HISTORIC LANDMARK COMMISSION
STAFF REPORT

Royal Crest Apartment Building
Legalization of Major Alterations Petition 470-07-44
830 East Sixth Avenue in the Avenues Historic District
January 16, 2008

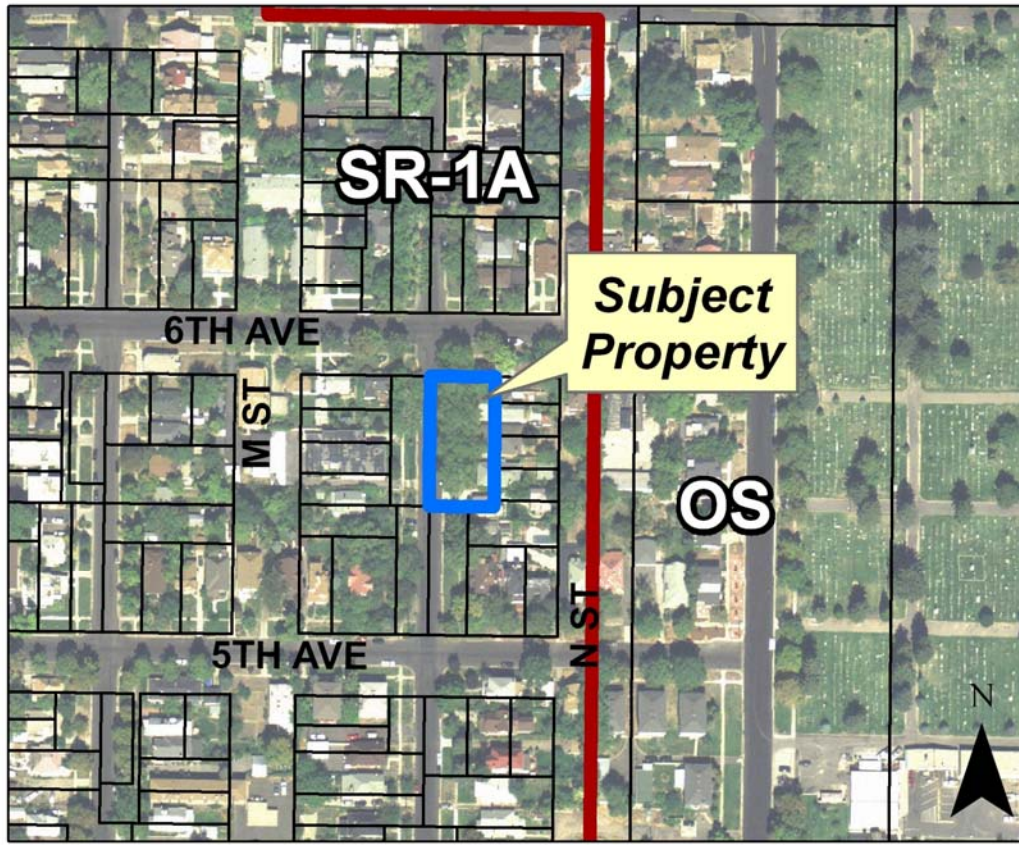
Staff finds that the alterations to the building located at 830 East Sixth Avenue significantly change important character-defining architectural features of the building and fails to substantially comply with all of the standards as stated in this staff report. Therefore, staff recommends that the Historic Landmark Commission deny the request to legalize the work initiated without a Certificate of Appropriateness. Staff recommends the following:

1. That the applicant obtains the appropriate City permits to re-establish the missing architectural features on the principal façade of this building including the decorative concrete block screen and panel.
2. The project must meet all other applicable City requirements, unless otherwise modified within the authority of the Historic Landmark Commission, Administrative Hearing Officer, or Board of Adjustment.
